APPEAL SUMMARY

Appeal ID: 20256	Project Address: 350 SW Jefferson St
Hearing Date: 4/17/19	Appellant Name: John Heinen
Case No.: B-009	Appellant Phone: 5035720476
Appeal Type: Building	Plans Examiner/Inspector: John Cooley, Joe Thornton, Corey Stanley
Project Type: commercial	Stories: 6 Occupancy: B Construction Type: 1-A
Building/Business Name: Wells Fargo Center	Fire Sprinklers: Yes - Throughout building
Appeal Involves: Alteration of an existing structure	LUR or Permit Application No.: 18-208035-CO
Plan Submitted Option: pdf [File 1]	Proposed use: Office Building

Appeal item 1

1 CODE COMPLIANCE PLAN - LEVEL 05
1/8" = 1'-0"

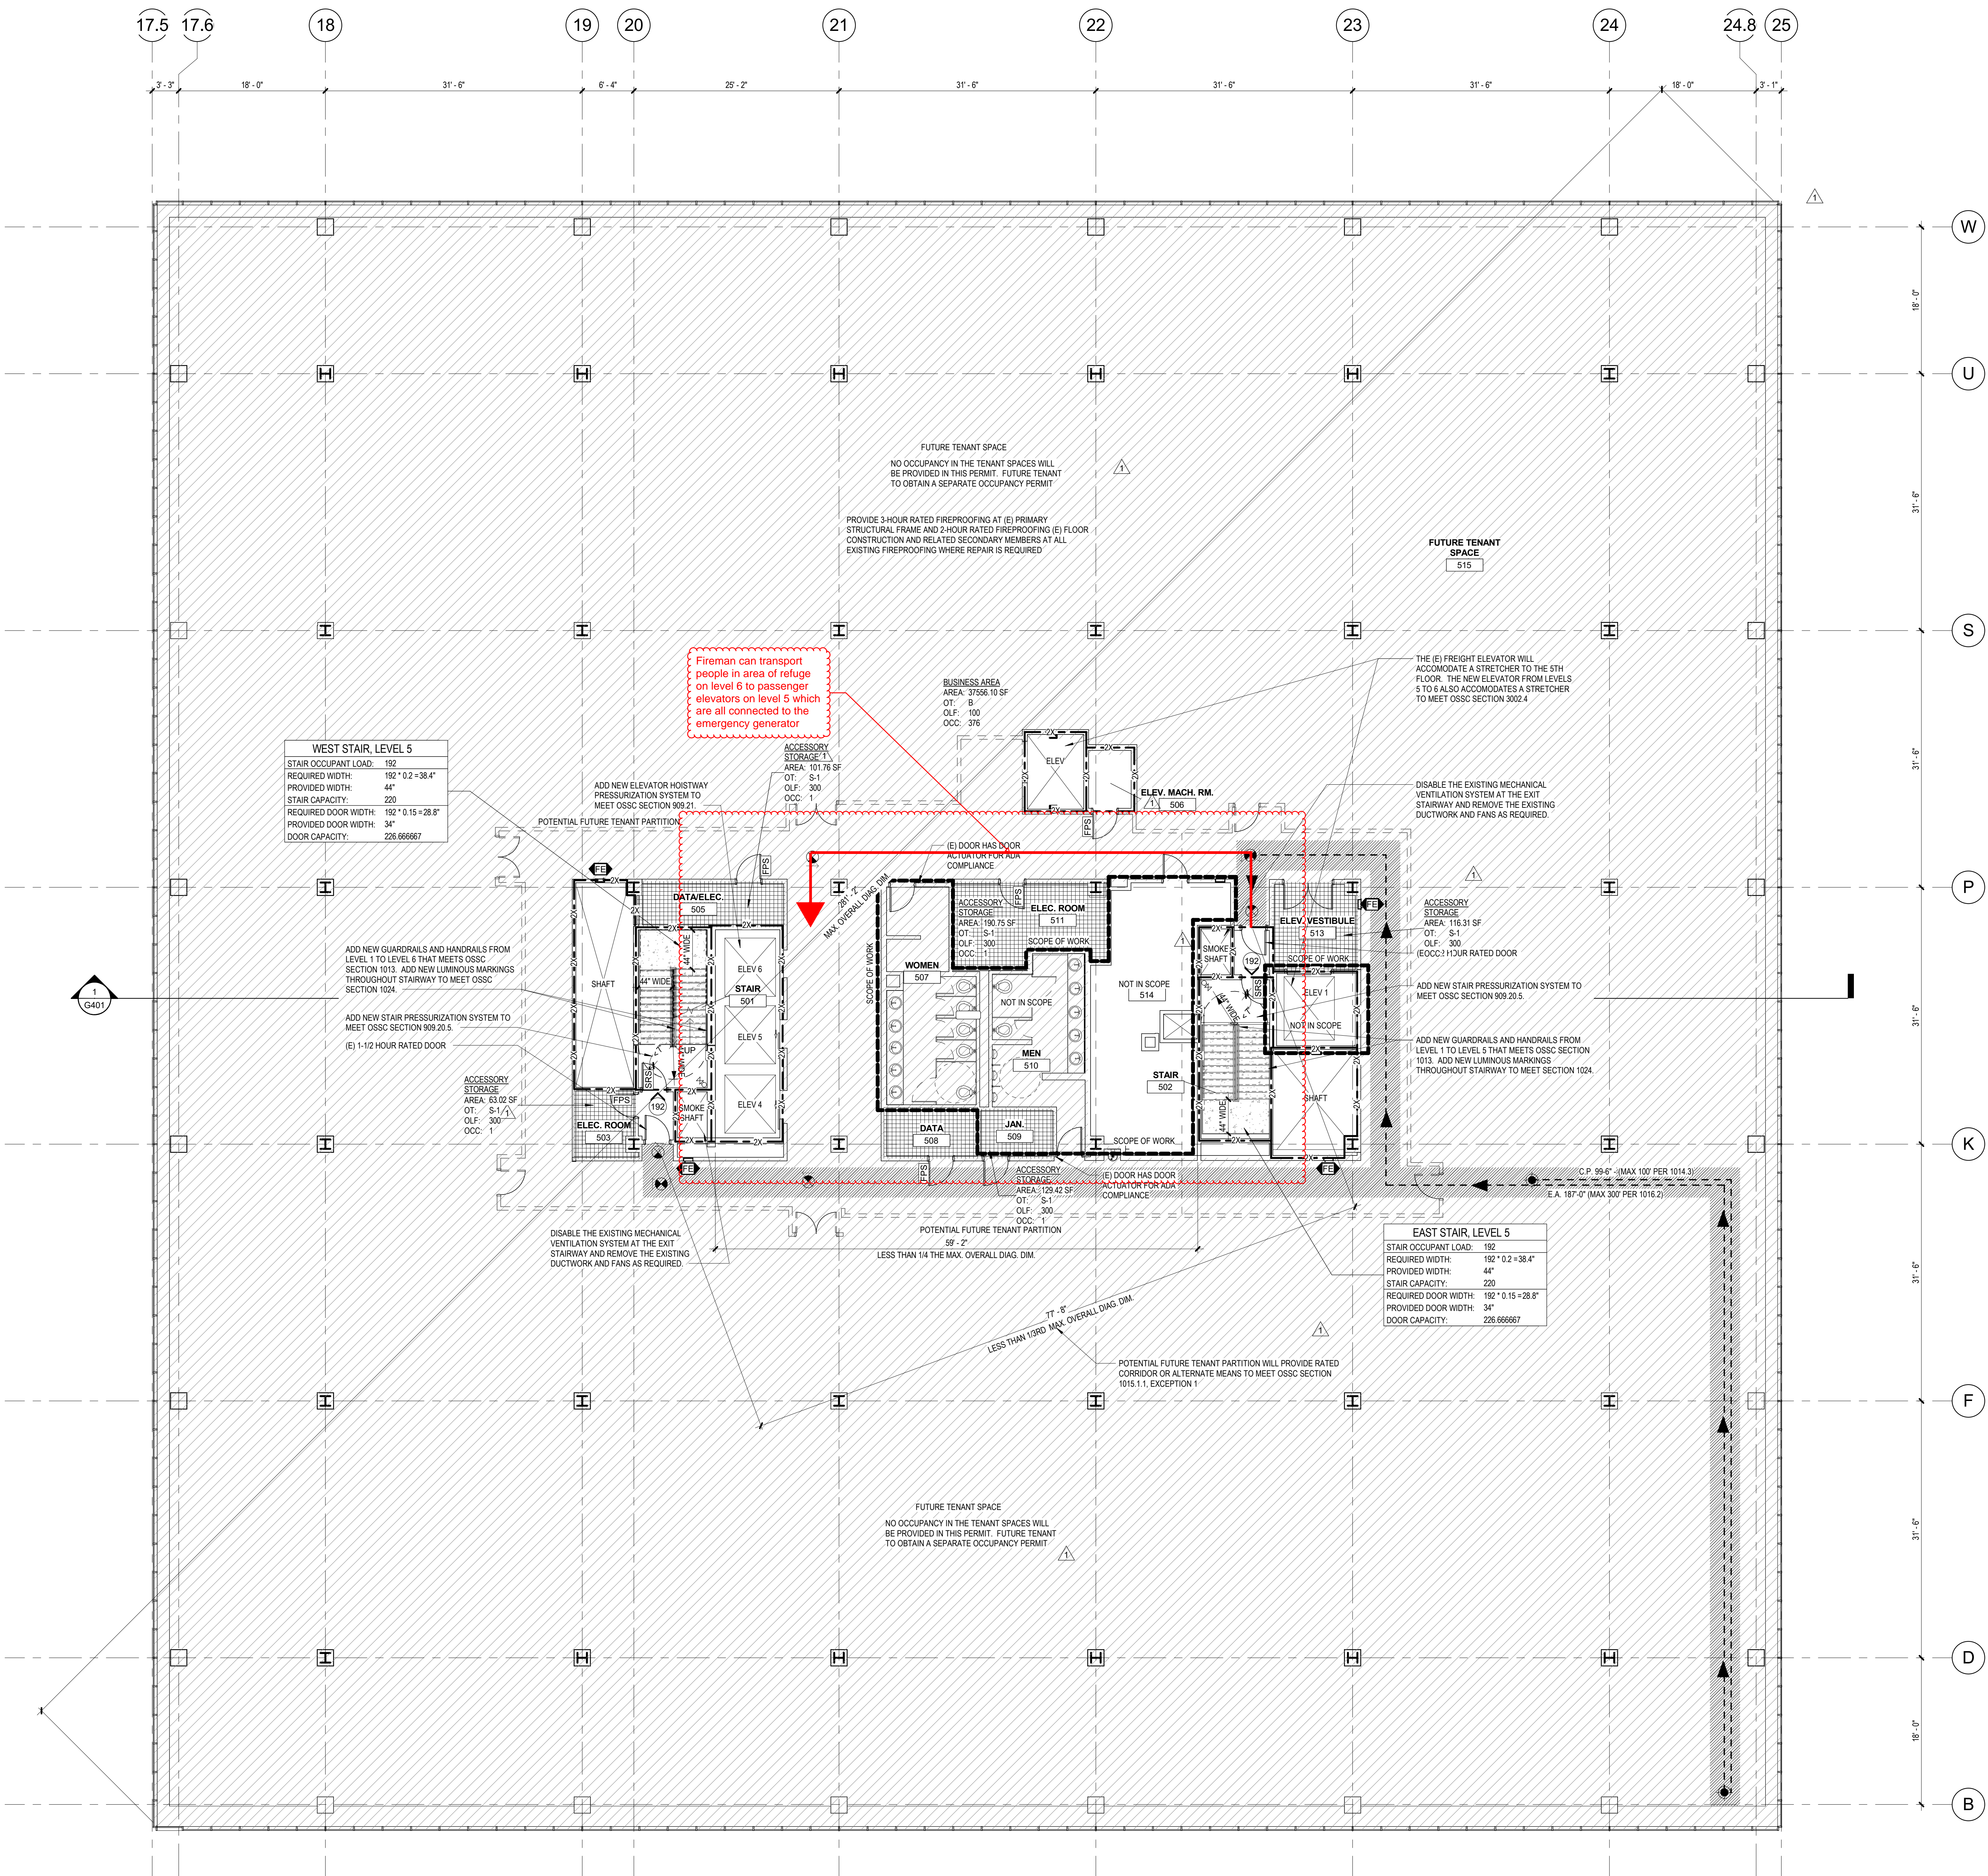
Please see the attached Fire Life Safety plan for level 5 and 6 for additional information.

1 CODE COMPLIANCE PLAN - LEVEL 06 ROOF
1/8" = 1'-0"

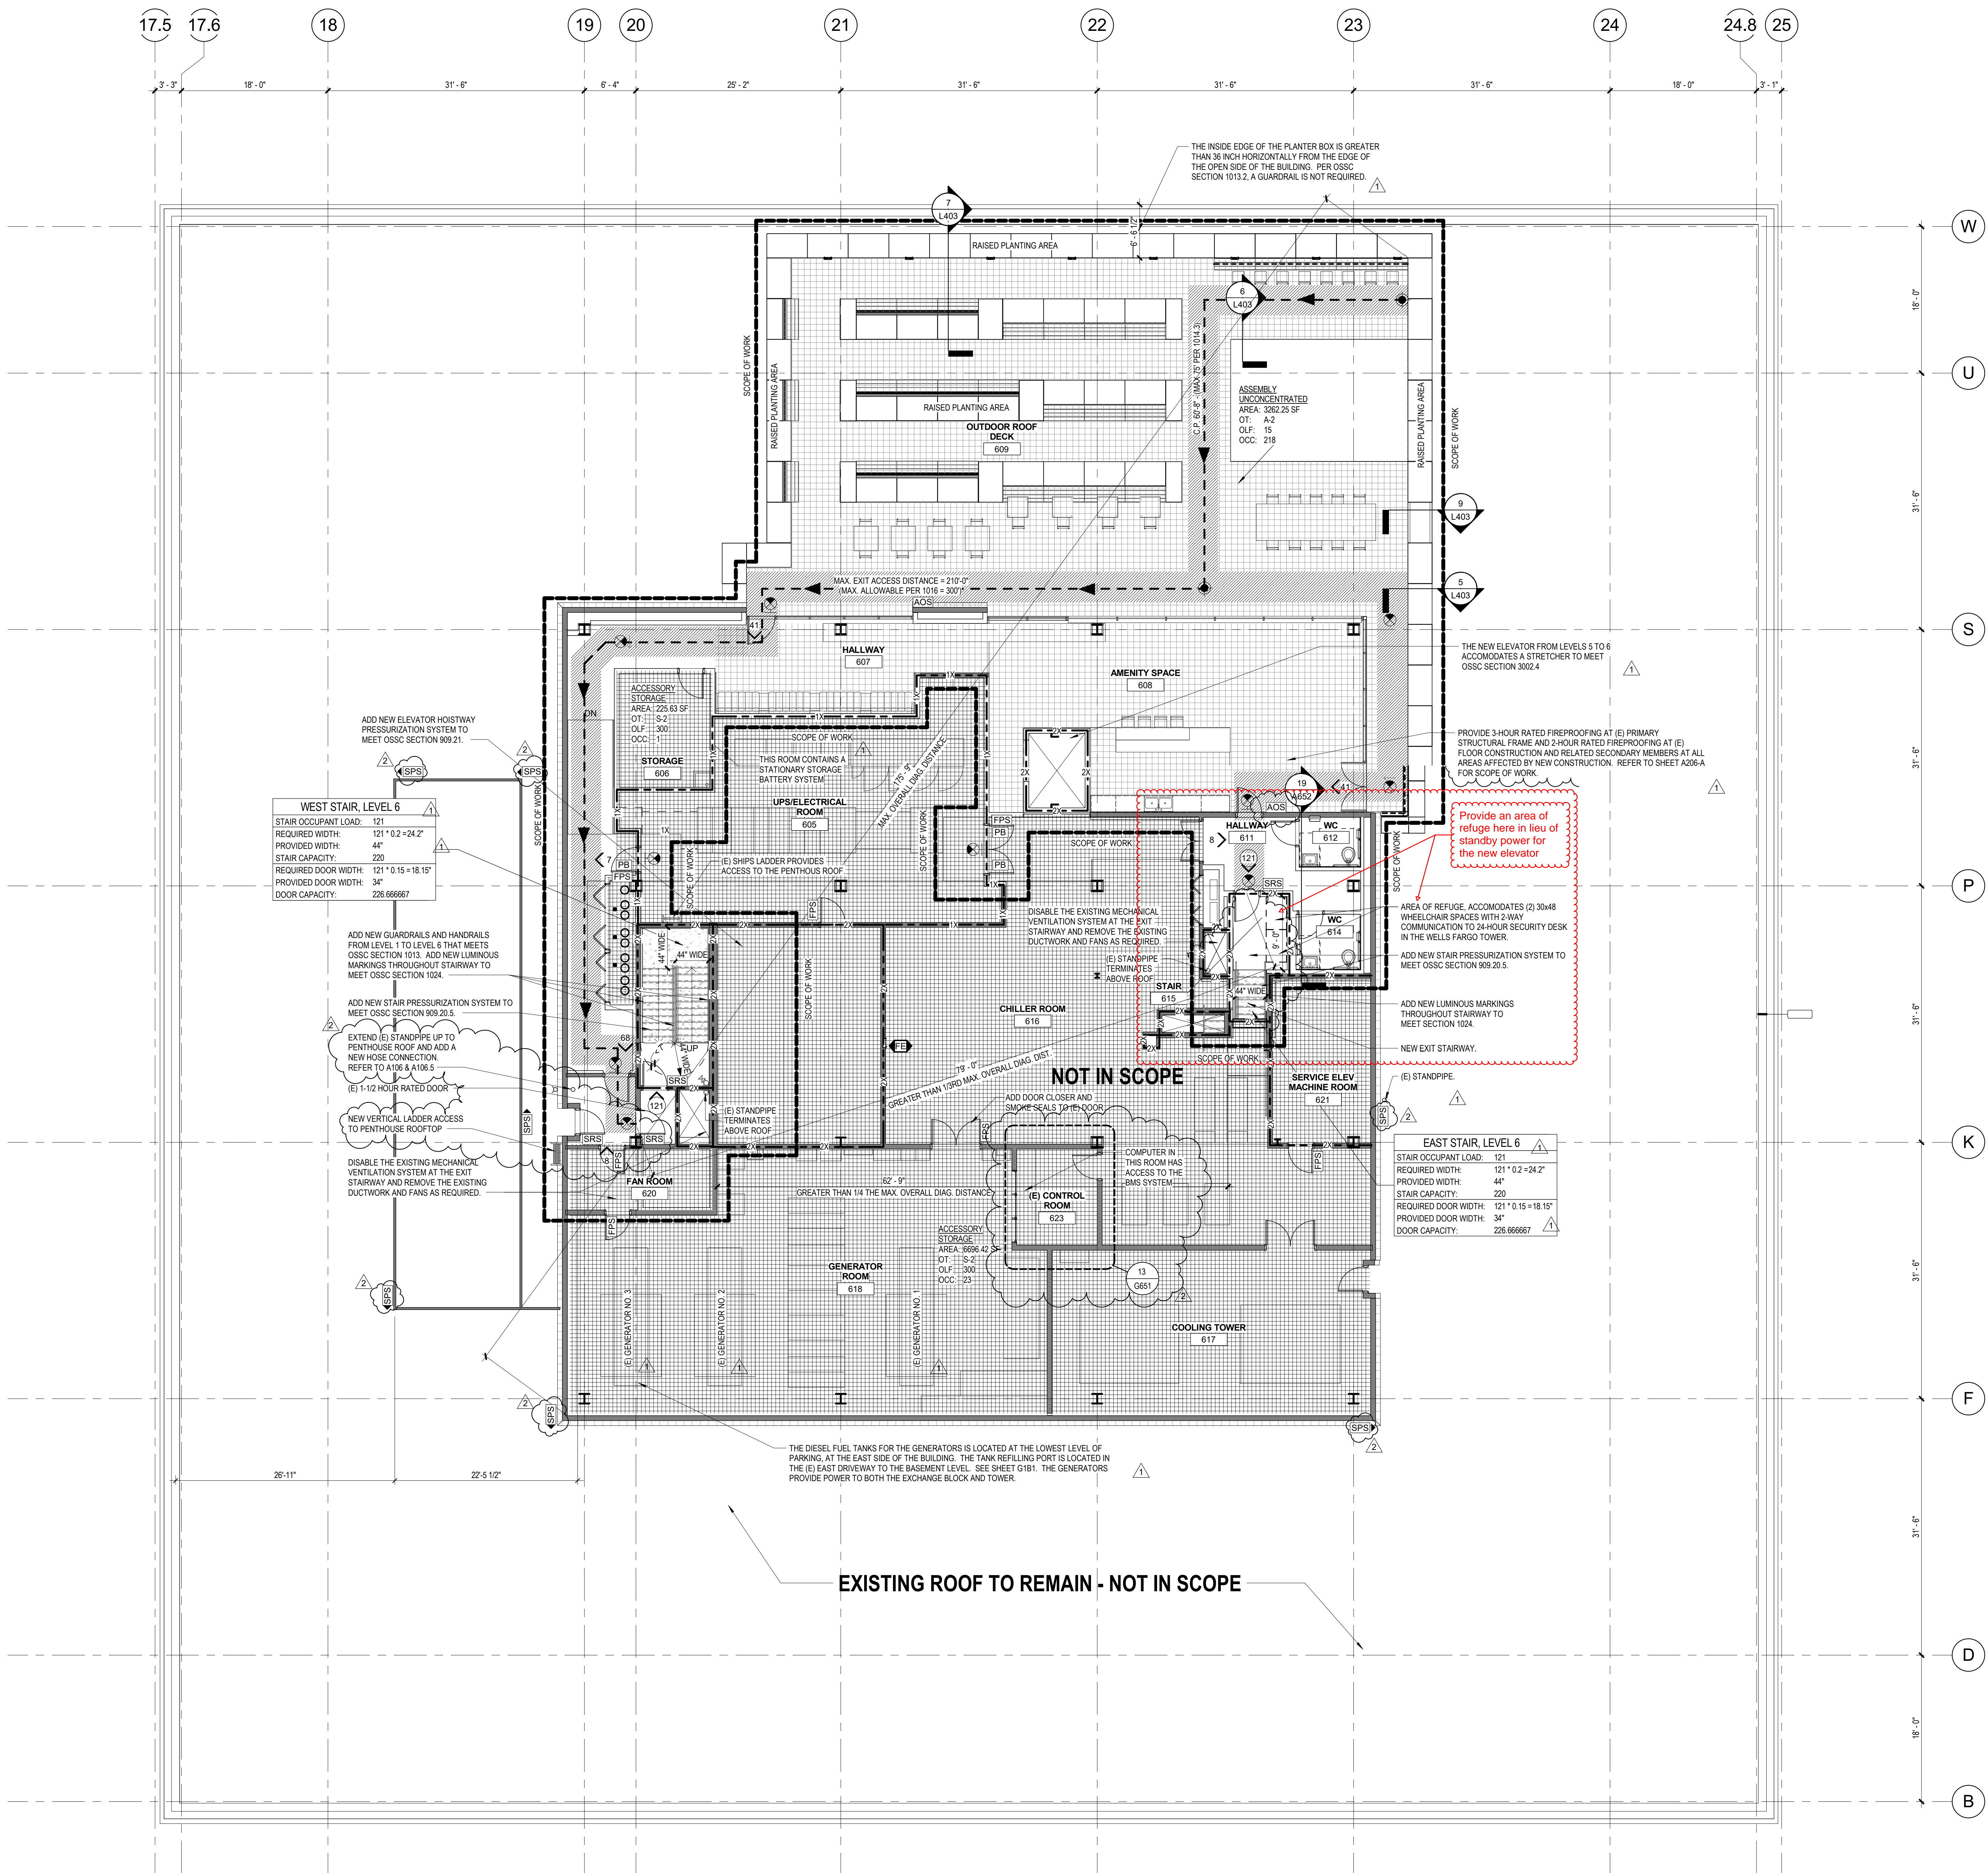
This appeal proposes to add an area of refuge to the level 6 landing in the new east stairway in lieu of providing standby power to the new elevator as required in Section 1007.4. The area of refuge will meet all the requirements in Section 1007.6 Areas of refuge, including one wheelchair space of 30 inches by 48 inches for each 200 occupants or portion thereof. Because the total load exiting from the floor is 242; (2) spaces will need to be provided. Two-way communication will also be provided to the existing 24 hour security desk in the nearby Wells Fargo Tower which functions as the Fire Command Center for the Wells Fargo Exchange Block. During an event, fireman can transport anyone in the area of refuge on level 6 to level 5 where there are existing passenger elevators that go from the basement to level 5. All the existing passenger elevators are connected to the emergency generator and can serve as an accessible means of egress elevator during an event.

Reason for alternative Adding an area of refuge to the level 6 landing in the new east stairway is an acceptable alternative to providing standby power to the new elevator per Section 1007.4 for the following reasons;

- The (2) area of refuge spaces will meet all the requirements in Section 1007.6 Areas of refuge.
- Area of refuge spaces are not currently required by code and will be an added safety feature to level 6.
- Two-way communication will also be provided to the existing 24 hour security desk in the nearby Wells Fargo Tower which functions as the Fire Command Center for the Wells Fargo Exchange Block.
- Rescue personnel can readily move people from level 6 to level 5 through the new extension of the exit stairway.
- All the existing passenger elevators running between the basement and level 5 are connected to the emergency generator and can serve as an accessible means of egress elevator during an event.

Proposal for area of refuge at Level 6 stairway in lieu of standby power for new elevator: Hold for additional information.
